ARMY AVIATION TEST BOARD FORT RUCKER ALA
INSTALLATION OF ATTITUDE AND DIRECTIONAL INDICATORS IN OH-23D H--ETC(U)
SEP 63

SUBJECT: Report of Test, USATECOM Project No. 4-3-3850-01-G,
Installation of Attitude and Directional Indicators in
OH-23D Helicopters

INSTALLATION OF ATTITUDE AND DIRECTIONAL INSTRUMENTS
IN OH-23D HELICOPTERS

FIGURE I-2

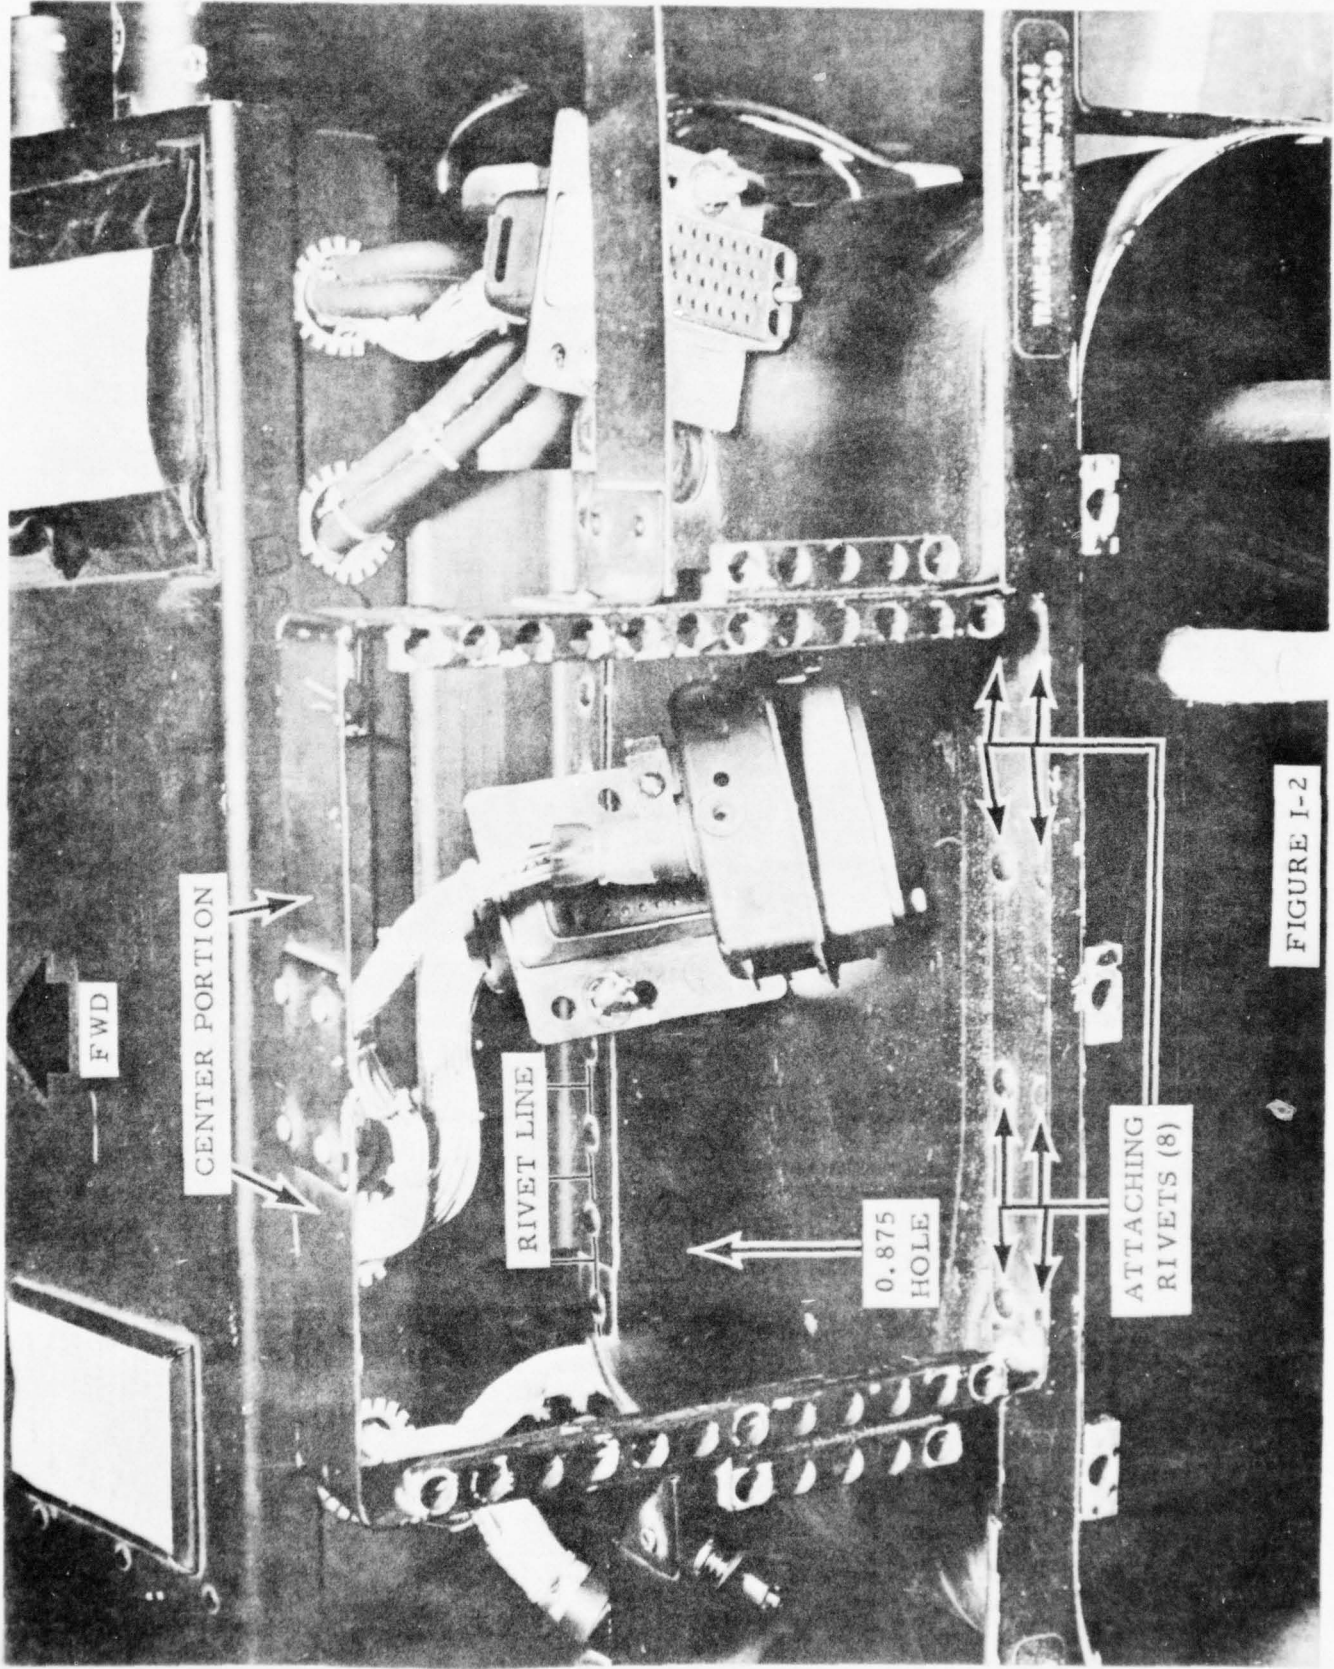
1. Remove the center portion of the support assembly by drilling out the eight attaching rivets. (See Figure I-2.)

(a) Cut a 0.875 inch diameter hole in the top of the control pedestal 3.375 inches left of the centerline and 1.125 inches aft of the existing rivet line shown in Figure I-2.

FIGURE I-3

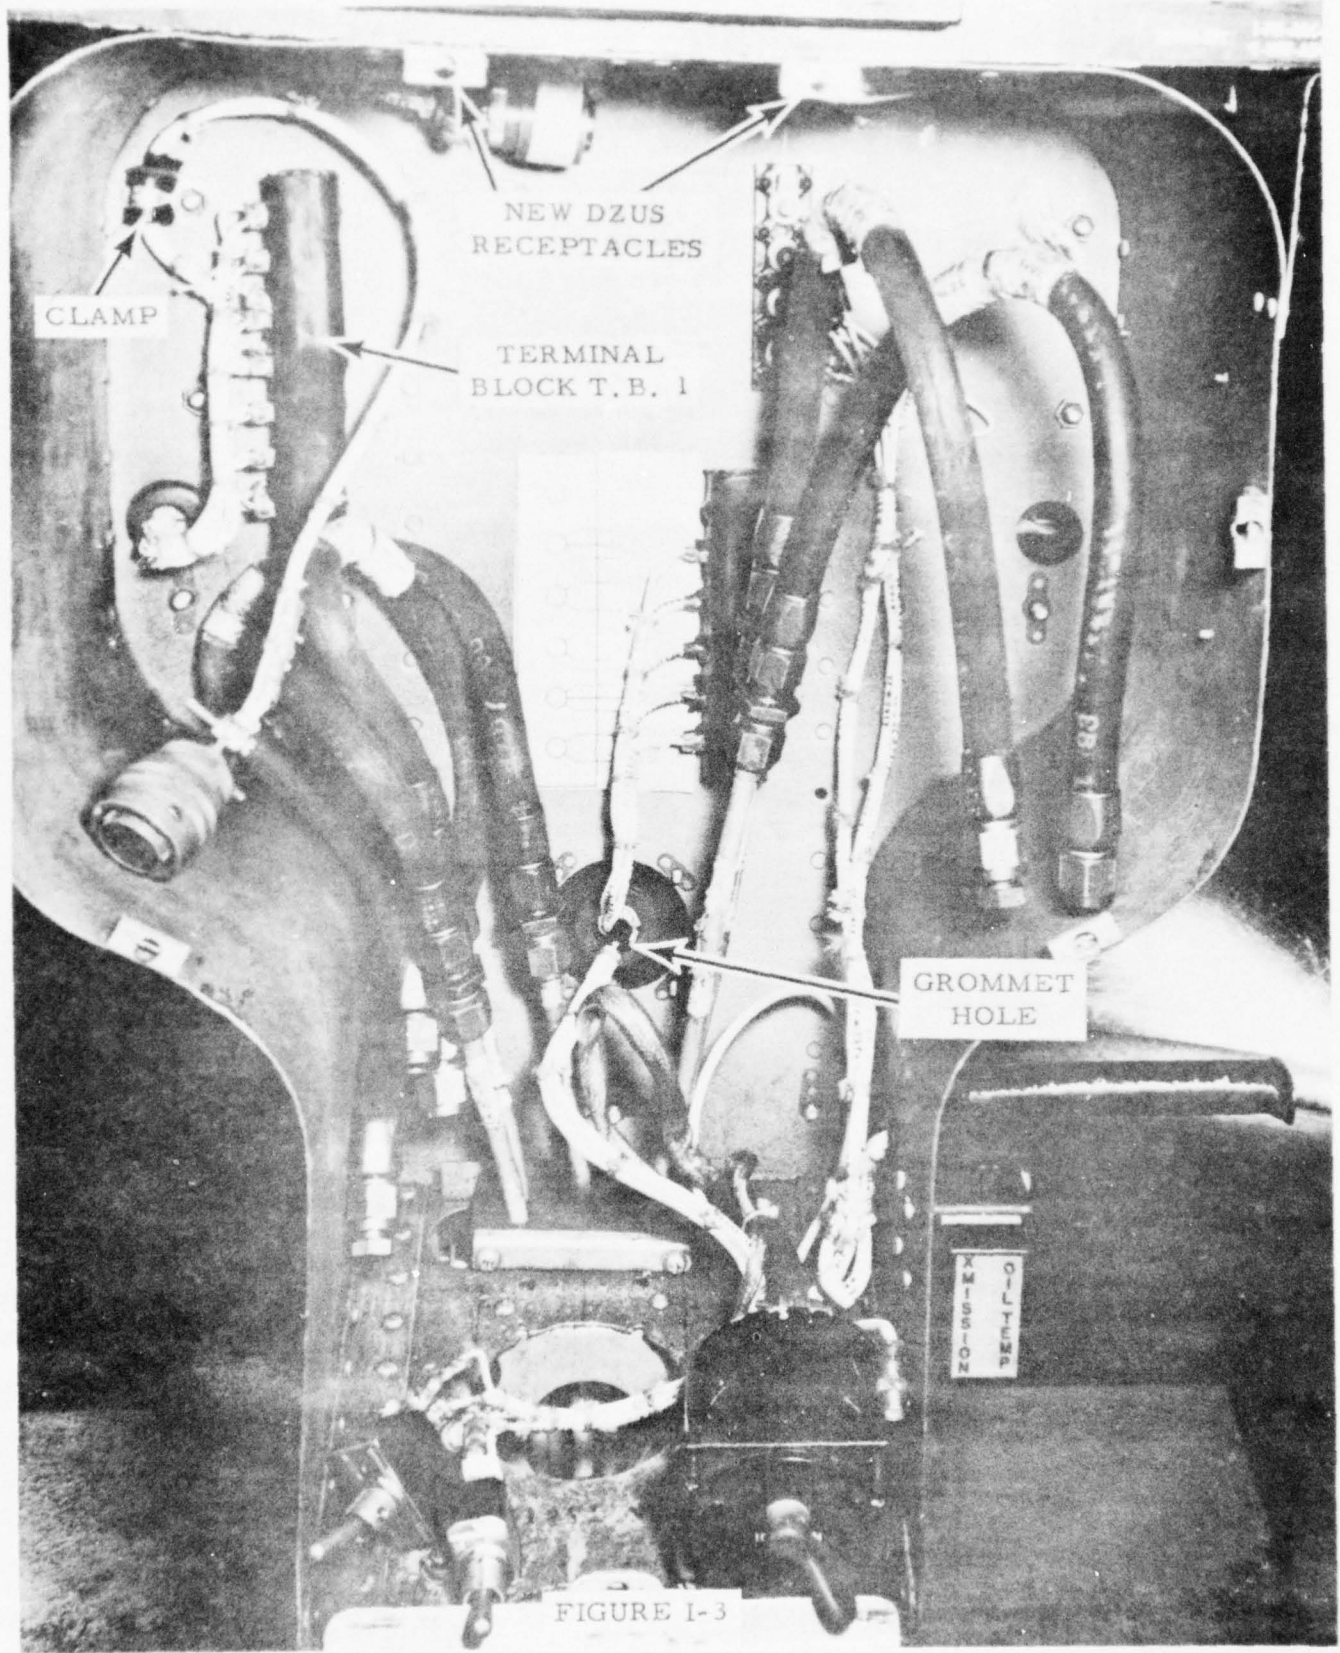
(h) Countersink the four holes, drilled in Step (f) above, from the top of the control pedestal to 0.218 inch diameter (100°), and install two Dzus receptacles (PRB 3-1/2) using four rivets (AN426AD4-6). (See Figure I-3.)

(k) Install T. B. 1 terminal block (AN3436-2-7) inside the control pedestal as follows: (See Figure I-3.)

(b) Secure harness assembly to the control pedestal (upper left corner) with one clamp (MS21919DG3) (see Figure I-3), using the existing mounting hole and hardware.

(a) From inside the pedestal, route harness assembly through the existing grommet hole in the center of the control pedestal. (See Figure I-3.)

FIGURE I-4

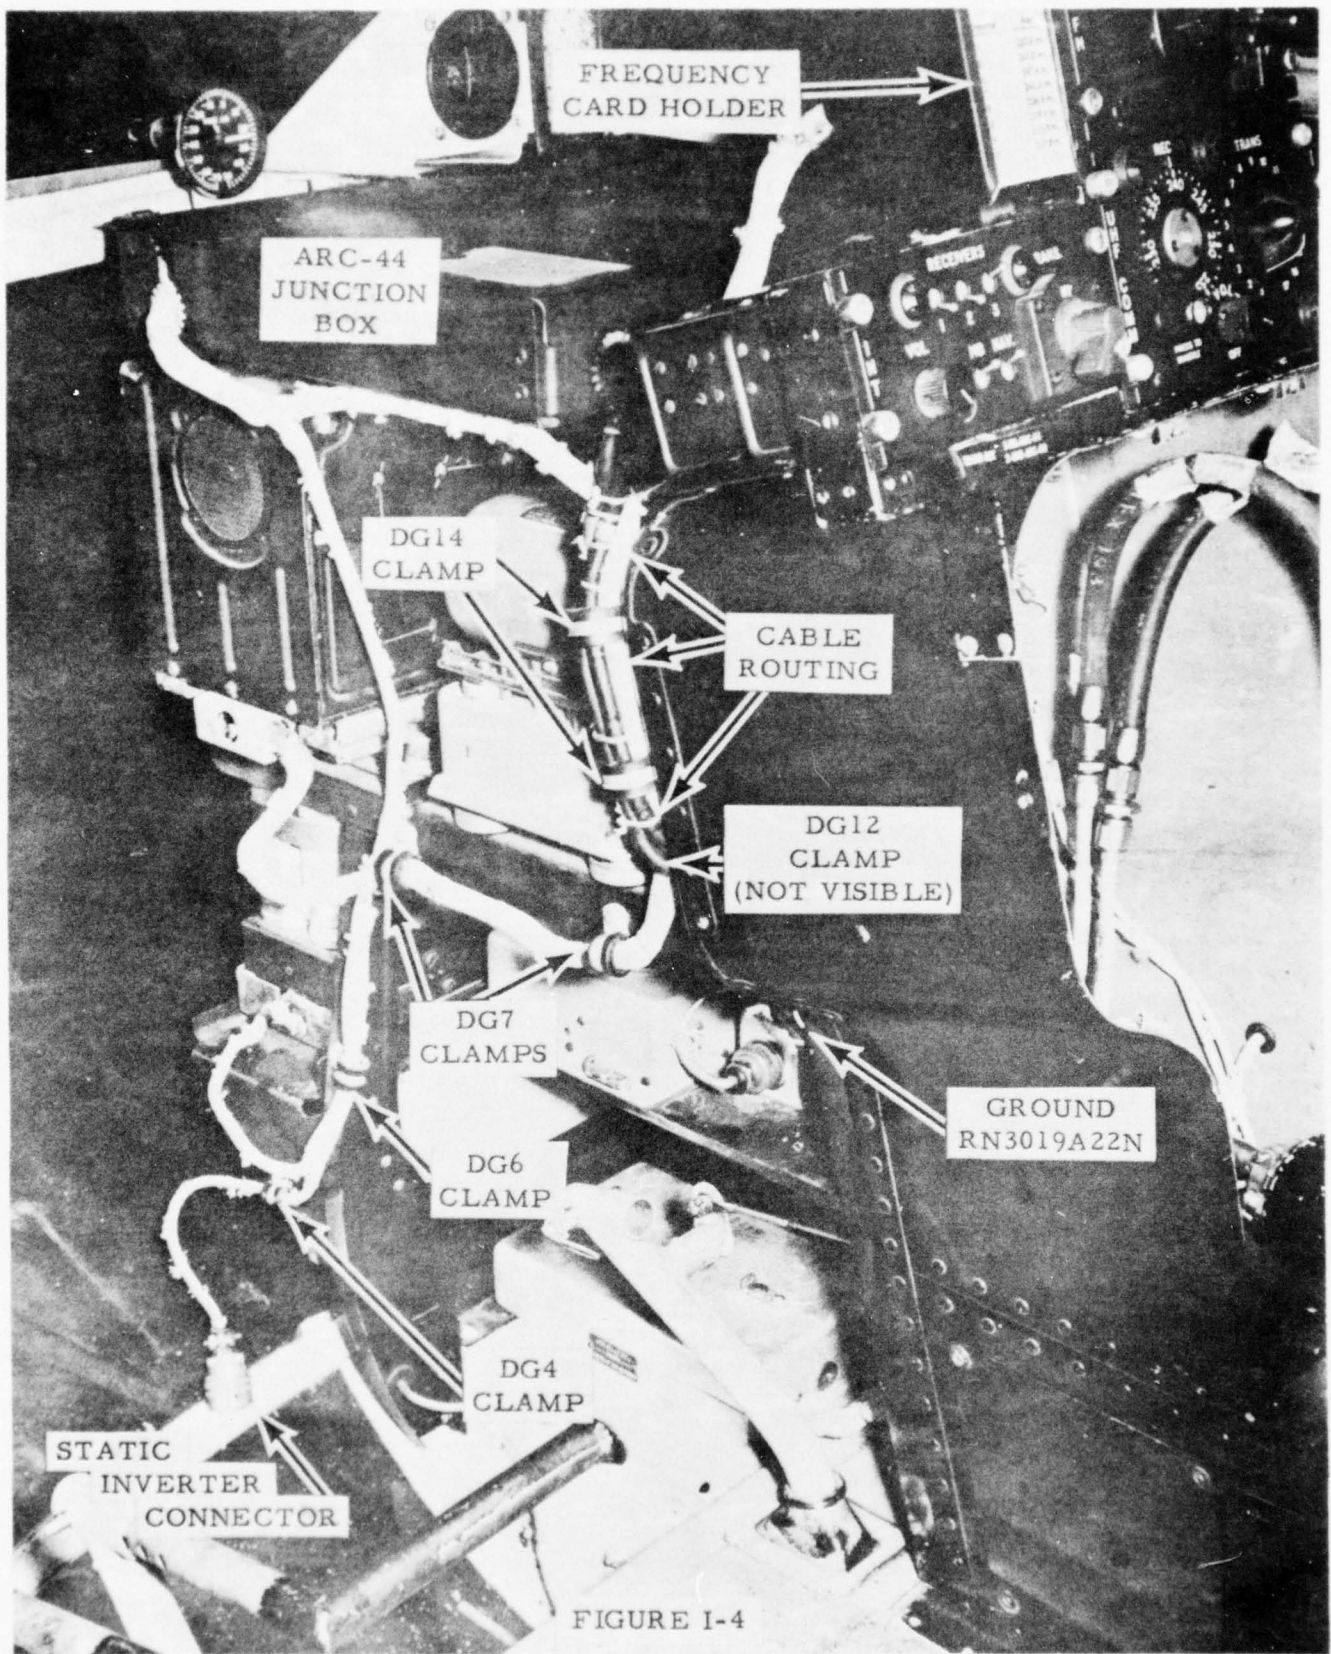
(d) Following existing cable, route Harness Assembly (Item 3) along the forward left side of the control pedestal (see Figure I-4) and down to the 0.812 inch diameter hole (see Figure I-1) in the control pedestal.

(c) Following existing wiring, route harness assembly to the left side of the control pedestal and into the AN/ARC-44 Junction Box located above the radio rack. (See Figure I-4.)

(b) Route harness assembly around left side of the rack which supports the DY-107/AR Dynamotor, and secure to the left side of the rack with one clamp (MS21919DG4), one screw (AN515DD832R8), two washers (AN960PD8), and one nut (AN365D832A) (see Figure I-4), utilizing existing hole.

(d) Secure the harness assembly to the radio racks by replacing three existing clamps with one clamp (MS21919DG6) and two clamps (MS21919DG7). Utilize existing hardware. (See Figure I-4.)

FIGURE I-5

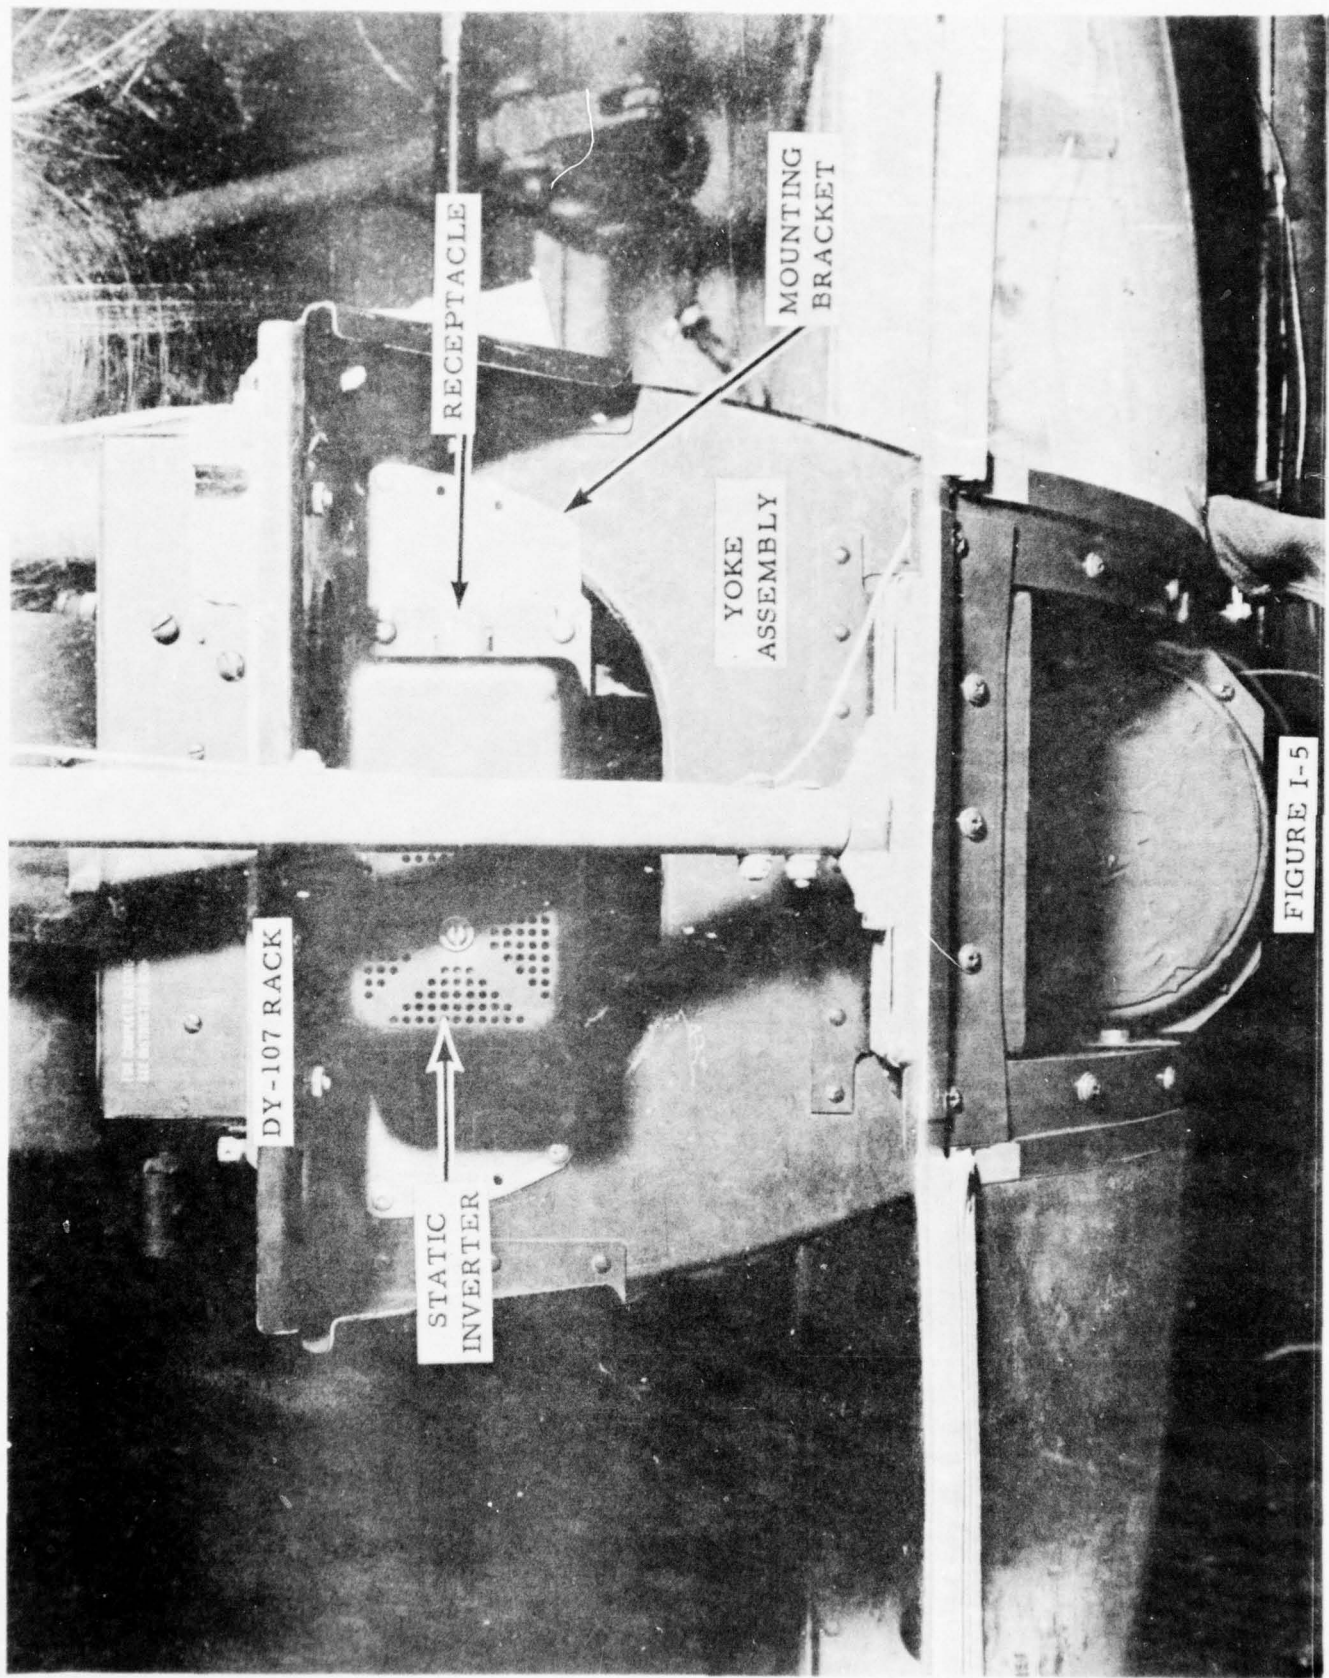
(5) Install Mounting Bracket (Item 11) for the static inverter on the forward side of yoke assembly (84225-3) (see Figure I-5), part of the radio racks located at Station 13.75, as follows:

(a) Position the mounting bracket against the forward side of the yoke assembly with the mounting bracket centered on center-line of the aircraft and with the two top corner rivet holes 0.75 inch below the rack which supports the DY-107/AR Dynamotor. The two flanges on the mounting bracket must be turned aft. (See Figure I-5.)

(6) Install static inverter (Sperry Type SI-111) on Mounting Bracket (Item 11) using four screws (AN515DD832R8), eight washers (AN960PD8), and four nuts (AN365D832A). The receptacle on the static inverter must be turned toward the left side of the aircraft. (See Figure I-5.)
